STATE OF RHODE ISLAND AND PROVIDENCE PLANTATION
DEPARTMENT OF TRANSPORTATION
RHODE ISLAND CONTRACT NO.2012-CB-063
FEDERAL-AID PROJECT NO. FAP Nos: STP-FRIP(250)

Wellington Ave Br Mitigation Phase I (FRIP C-2B) - TYPE 2 Emergency Contract

NOTICE TO PROSPECTIVE BIDDERS

ADDENDUM NO. 1 Prospective bidders and all concerned are hereby notified of the following changes in the Plans, Specifications, Proposal and Distribution of Quantities for this contract. These changes shall be incorporated in the Plans, Specifications, Proposal and Distribution of Quantities, and shall become an integral part of the Contract Documents.

<small>AECOM 10 ORMS ST. - PROVIDENCE, RHODE ISLAND - 02904</small>	TITLE OF SKETCH PROPOSED HAUL ROAD REMOVAL PLAN ST 0+00 TO STA 4+80	R.I. CONTRACT No. 2012-CB-073	Sketch No. 1
May 1, 2012	Addendum No. 1	Revision to Dwg. No. 0112M_V1_008_PLAN Sheet 8

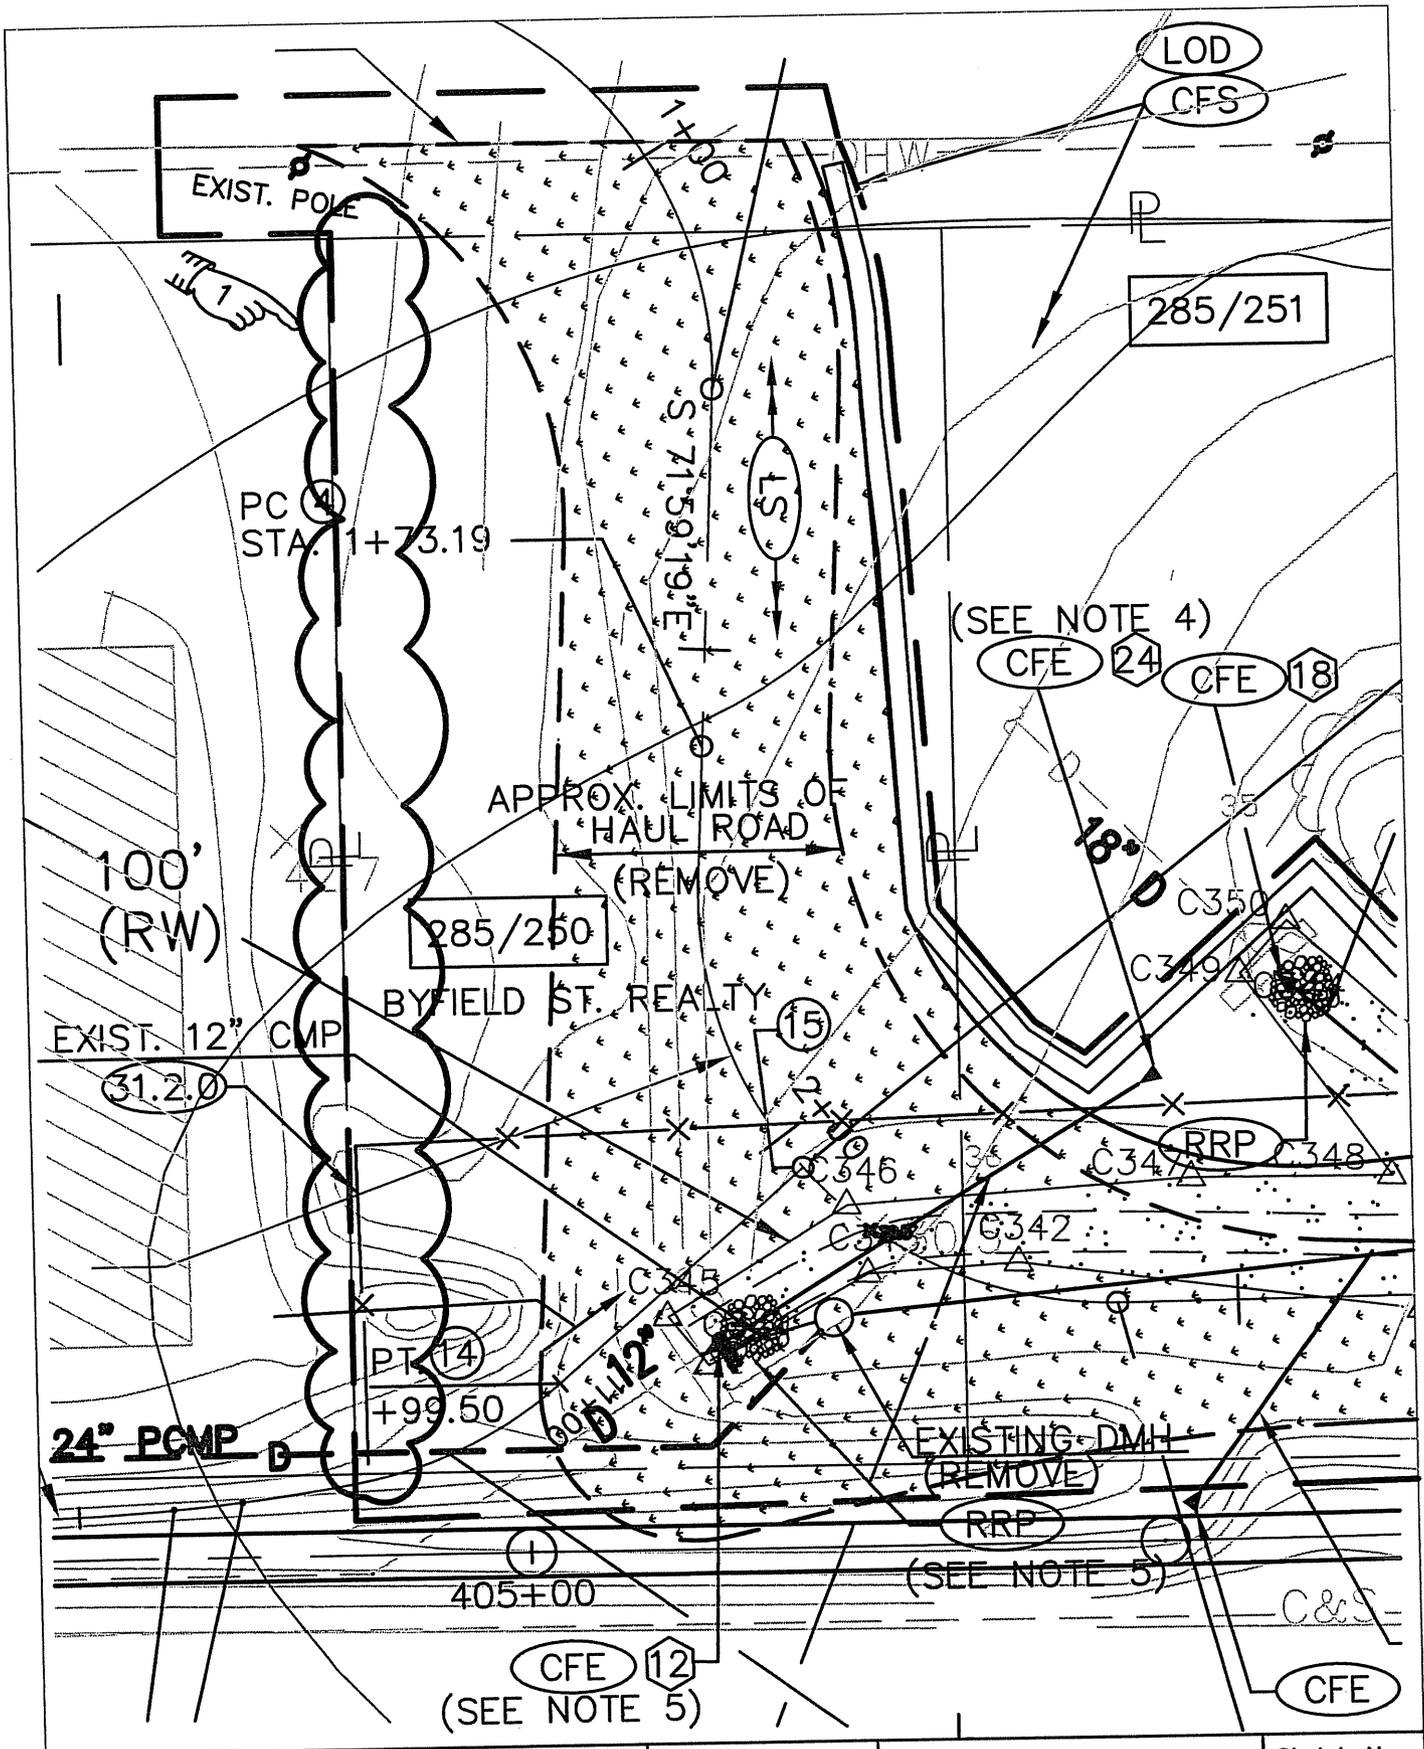
1. Job-Specific Specifications
Add specification L05.9901, Permanent Erosion Control Blanket, attached to this Addendum No. 1. This item of work has been added to the contract.
2. Plans
Revise Sheet 8 as shown on Sketches 1 through 4 attached to this Addendum No. 1.
